CONTRACT CHANGE ORDER NO. 257
SHEET 3 OF 4

SAN FRANCISCO OAKLAND BAY BRIDGE
EAST SPAN SEISMIC SAFETY PROJECT
SELF-ANCHORED SUSPENSION BRIDGE
(SUPERSTRUCTURE & TOWER)

TYPICAL GIRDER DETAILS NO. 12

TYPICAL GIRDER DETAILS NO. 17A

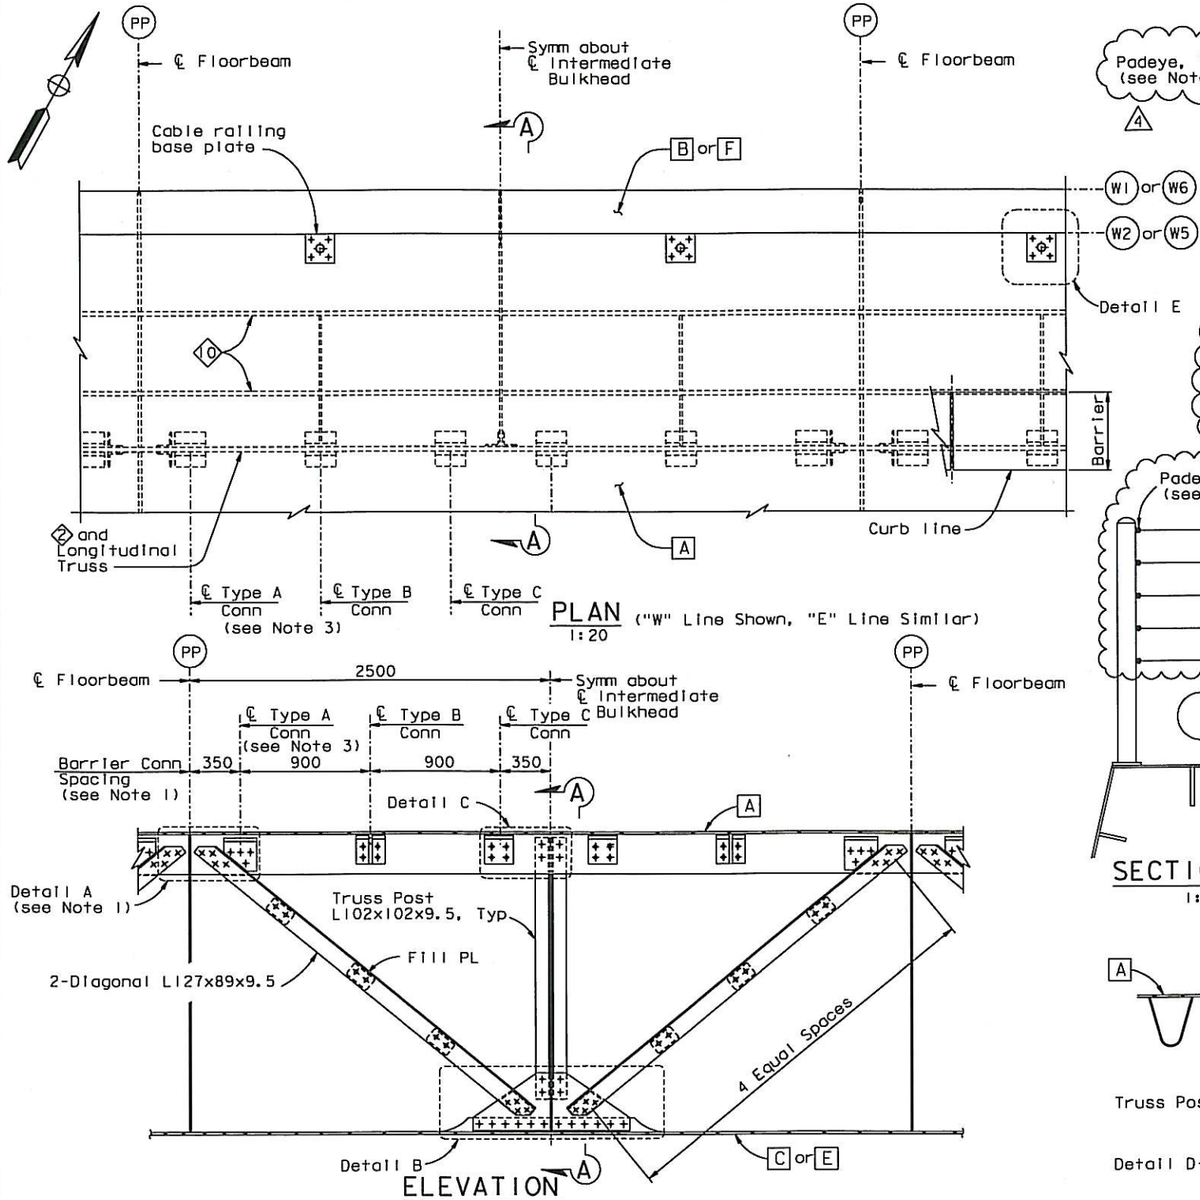
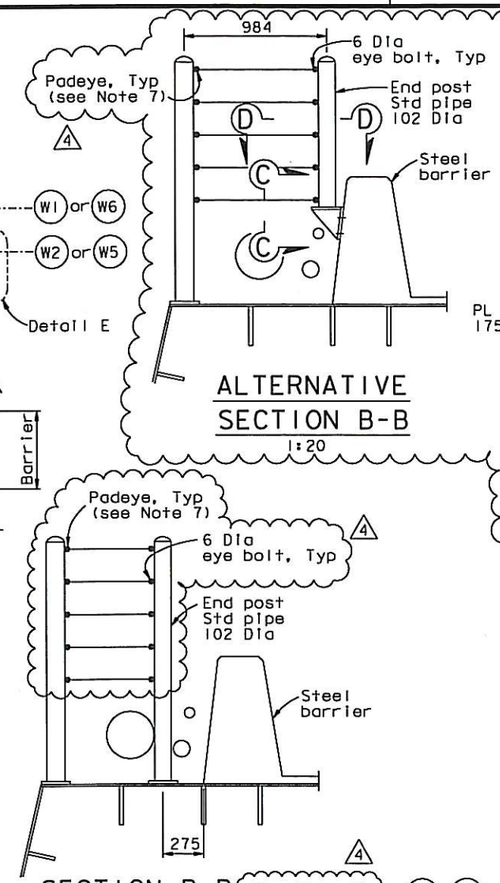
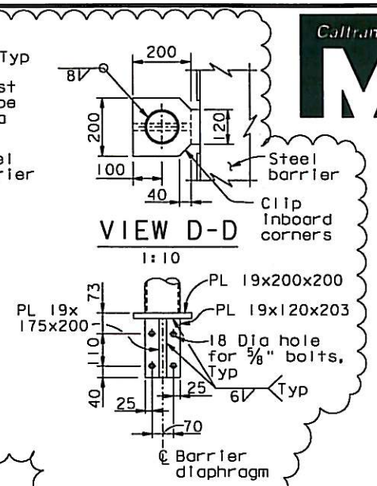
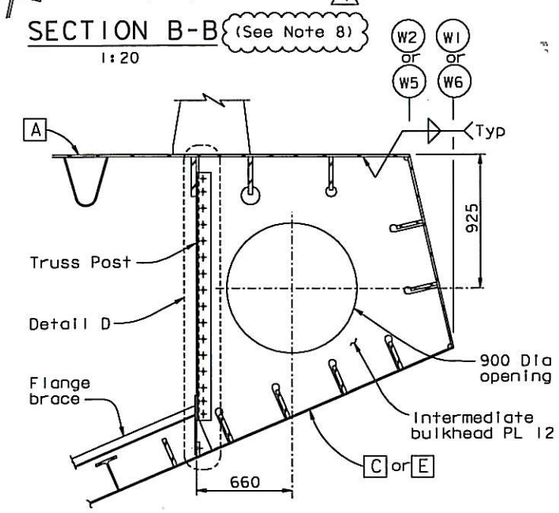
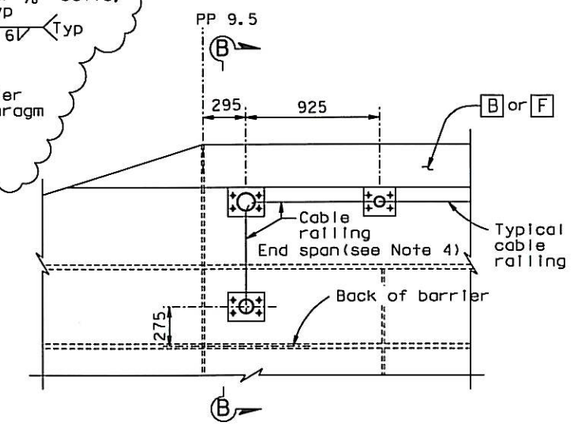
MARK	DATE	DESCRIPTIONS	BY	CH'D	CCO#
4	04/17/13	CABLE RAILING INSTALL	AB	DT	257
3	11/16/11	CABLE RAILING	GB	DT	188
2	05/15/09	HANDRAIL	GB	DT	114
1	08/24/07	BARRIER MODIFICATIONS	GB	DT	44

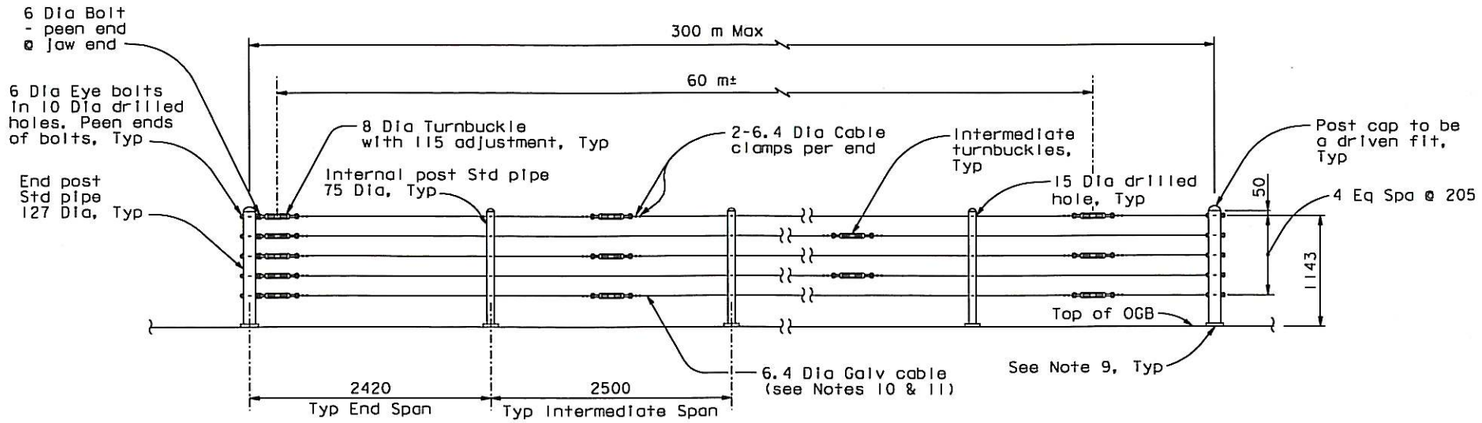
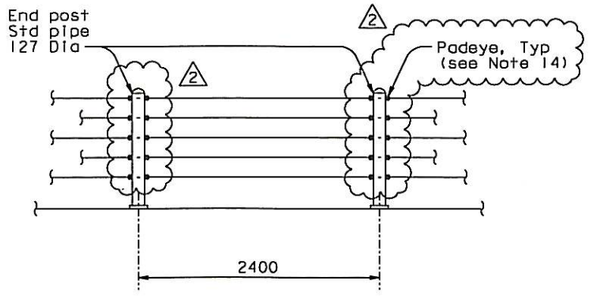
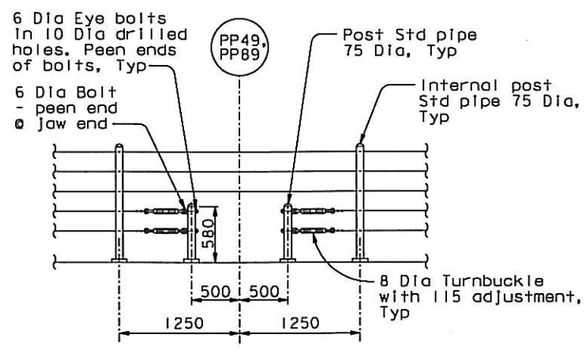
MARK	DATE	DESCRIPTIONS	BY	CH'D	CCO#
2	04/17/13	CABLE RAILING INSTALL	AB	DT	257
1	05/11/12	CABLE RAILING	DT	HT	188
0	05/15/09	HANDRAIL	GB	TH	114
